SUBJECT: SEABROOK STATION, UNIT NO. 1 – STAFF ASSESSMENT OF RESPONSE
TO 10 CFR 50.54(f) INFORMATION REQUEST – FLOOD-CAUSING
MECHANISM REEVALUATION (CAC NO. MF6782; EPID NO.
000495/05000443/L-2015-JLD-0019)

Enclosure:
Staff Assessment of Flood Hazard
Reevaluation Report for Seabrook

STAFF ASSESSMENT BY THE OFFICE OF NUCLEAR REACTOR REGULATION

SEABROOKSTATION, UNIT NO. 1

Figure 3.2-1. Maximum LIP flow depth (east portion of site). Indices of POIs included. (Source: FHRR Figure 4-12).

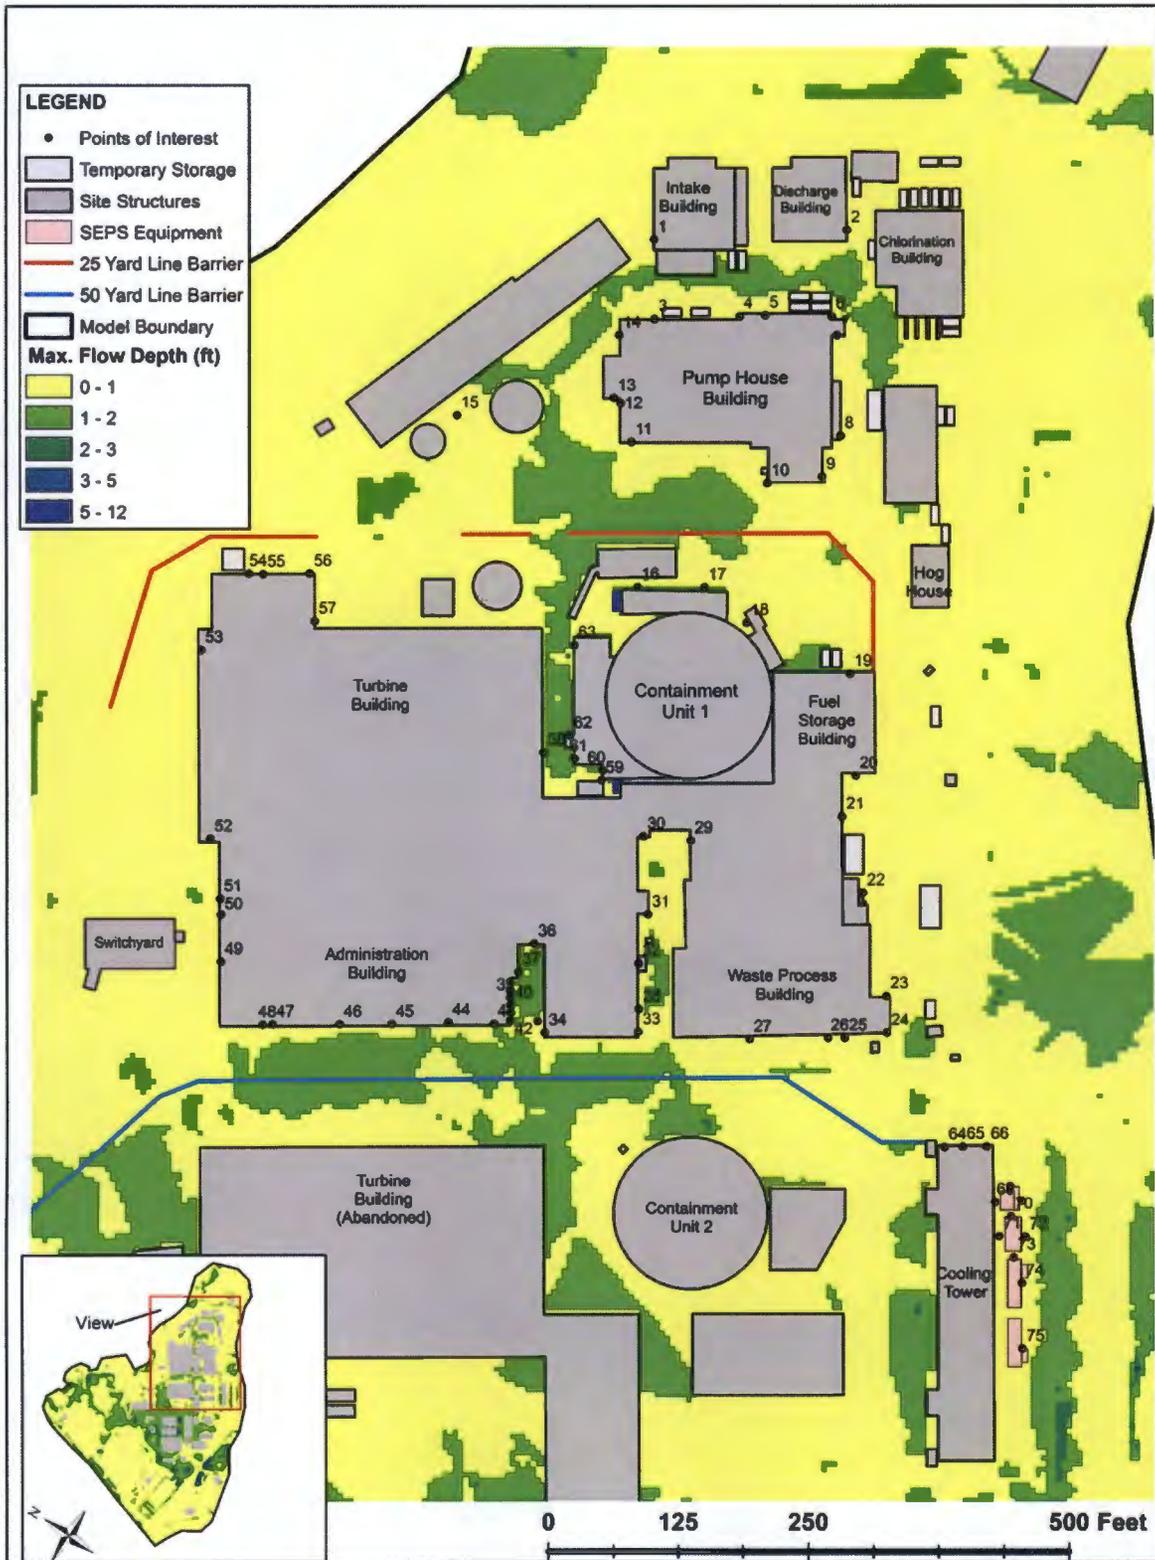
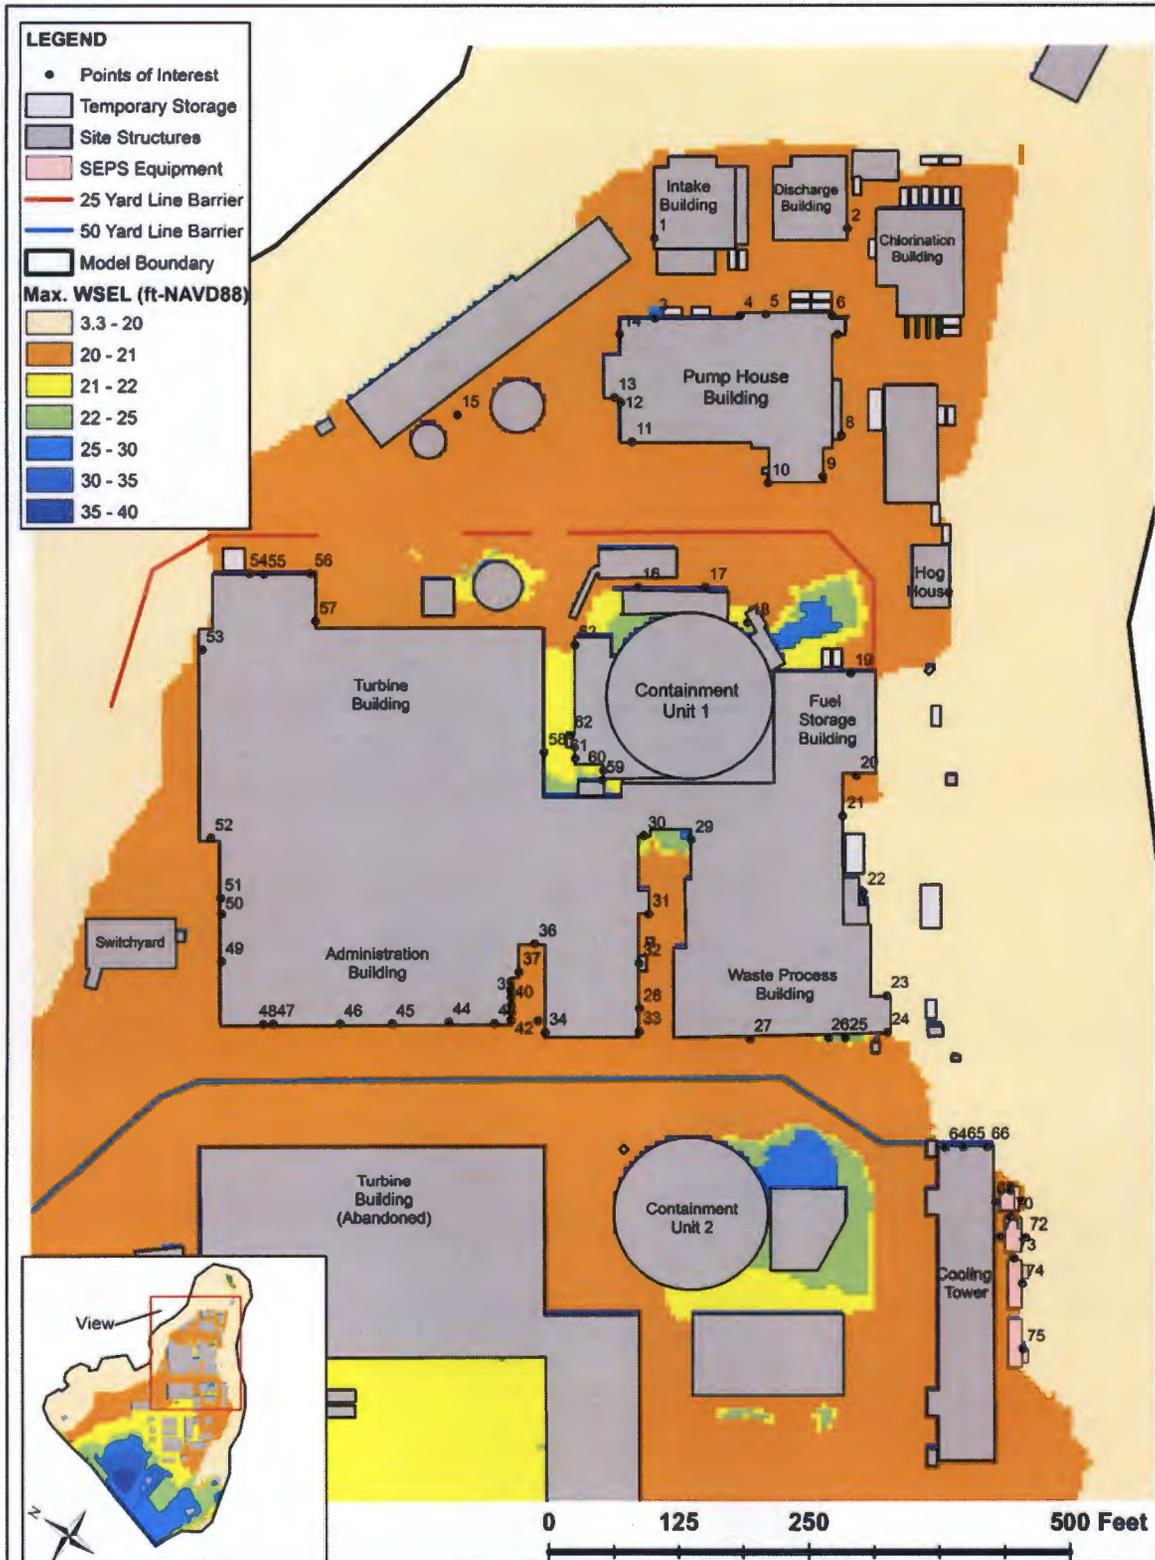
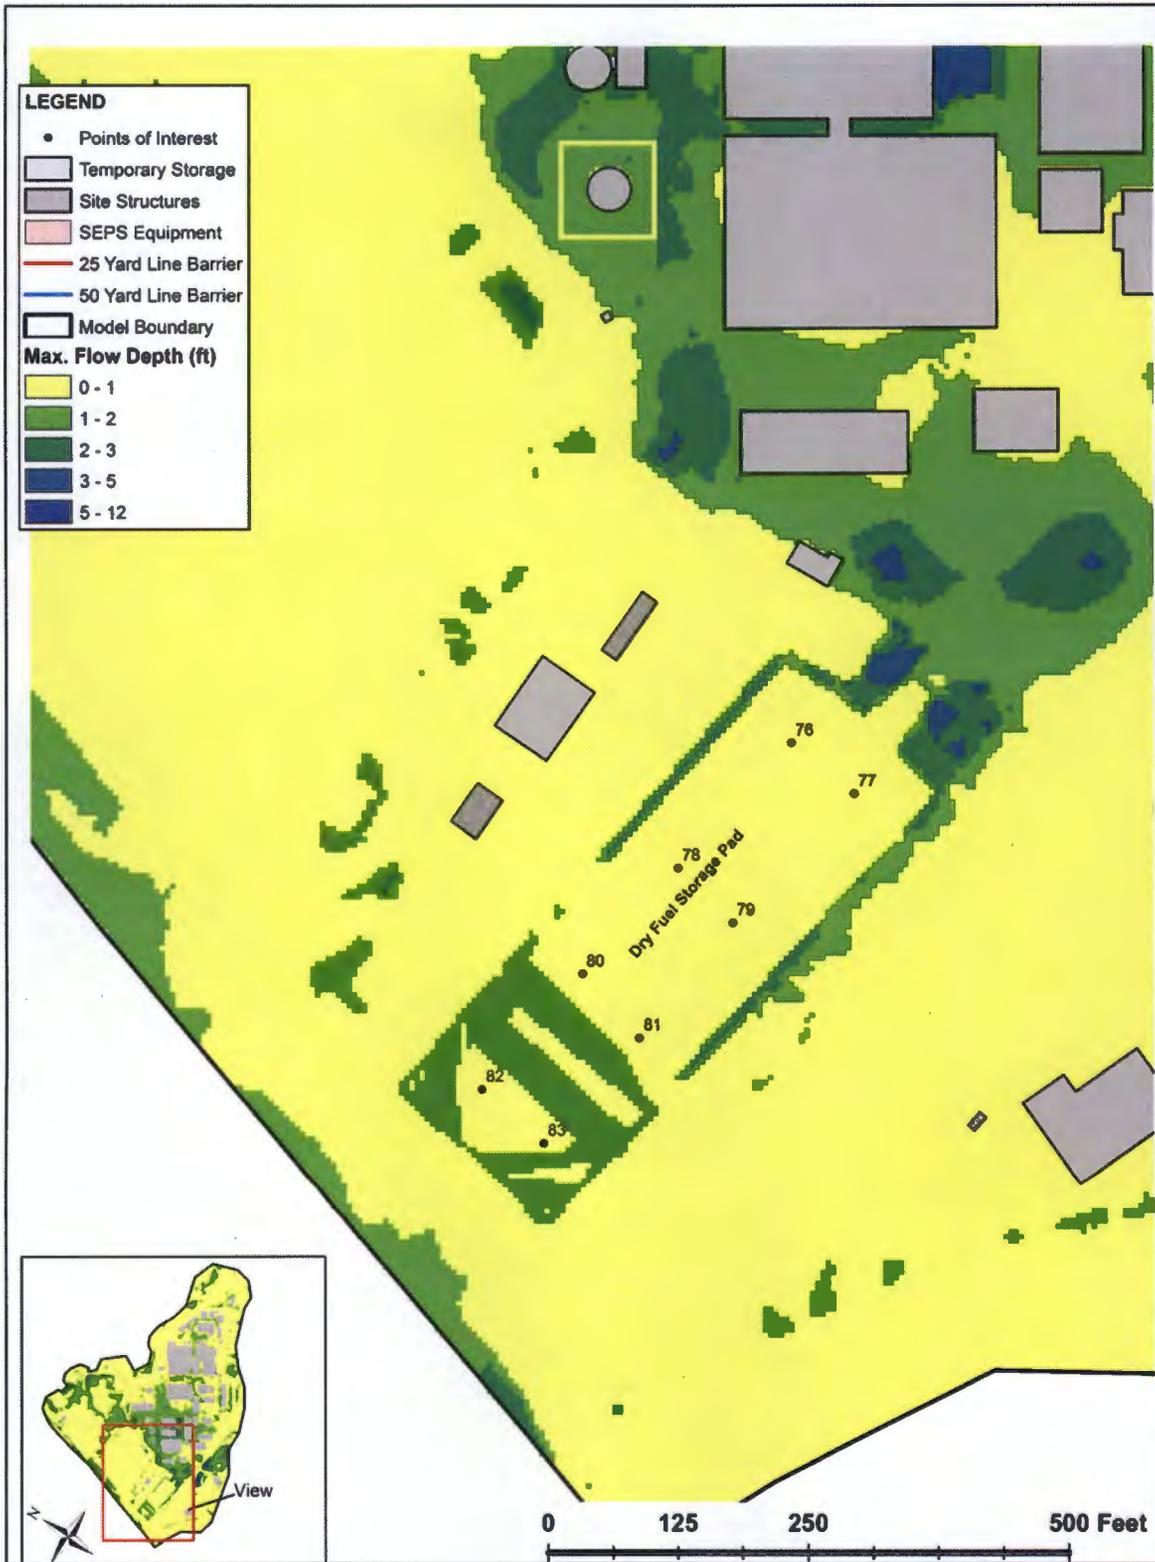
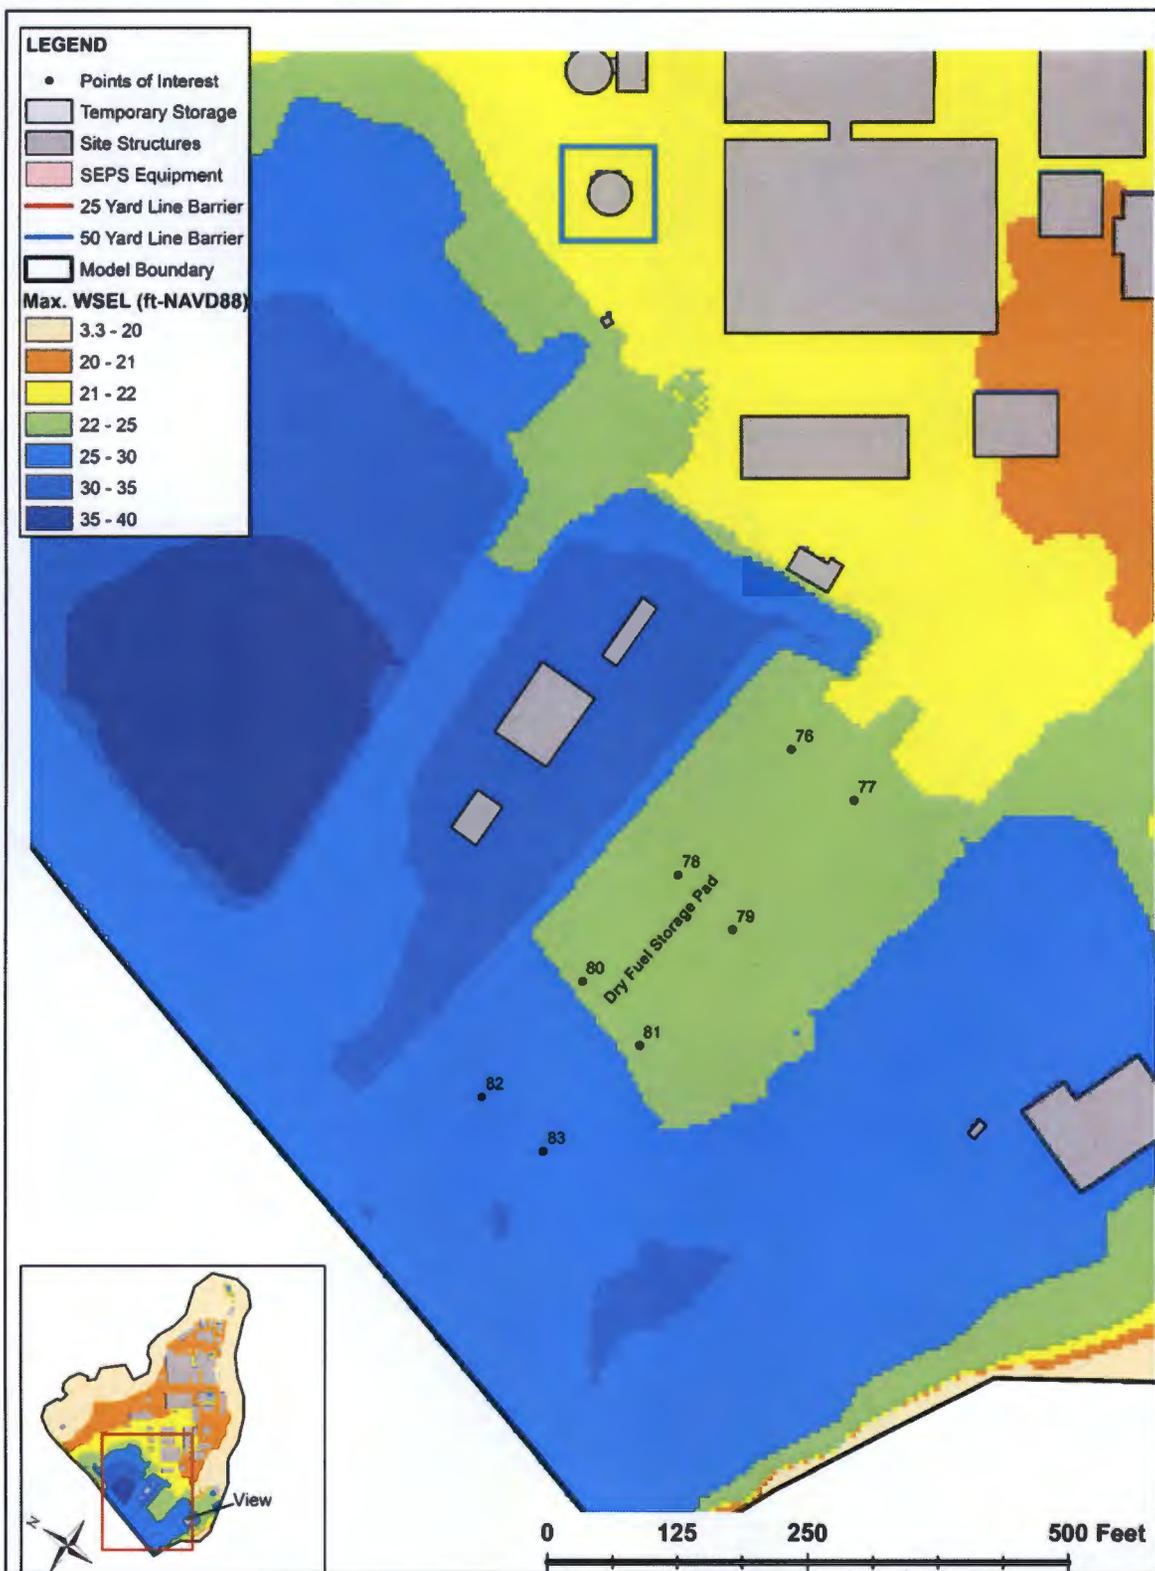
The NRC staff reviewed the licensee's model setup including the hydraulic parameters, surface topography, hydraulic boundary conditions, and the grid resolution in the FLO-2D model. The NRC staff checked the modeling's mass conservation error, and found the value to be reasonable. The licensee's LIP maximum flood depths and peak water surface elevations are shown for the east portion of the site in Figure 3.2-1 and Figure 3.2-2, respectively in this assessment. The licensee's LIP maximum flood depths and peak water surface elevations are shown for the west portion of the site in Figure 3.2-3 and Figure 3.2-4, respectively in this assessment. These figures also show the locations of the 83 points of interest.

The grid size in the two-dimensional FLO-2D model was 5 ft. by 5 ft. The licensee chose this grid size to fit the resolution of local flow path and to represent 83 critical locations within the plant site. The computational time step was set to satisfy a Courant number less than one. The NRC staff found that both grid size and computational time step were reasonably selected for the flood hazard analysis.
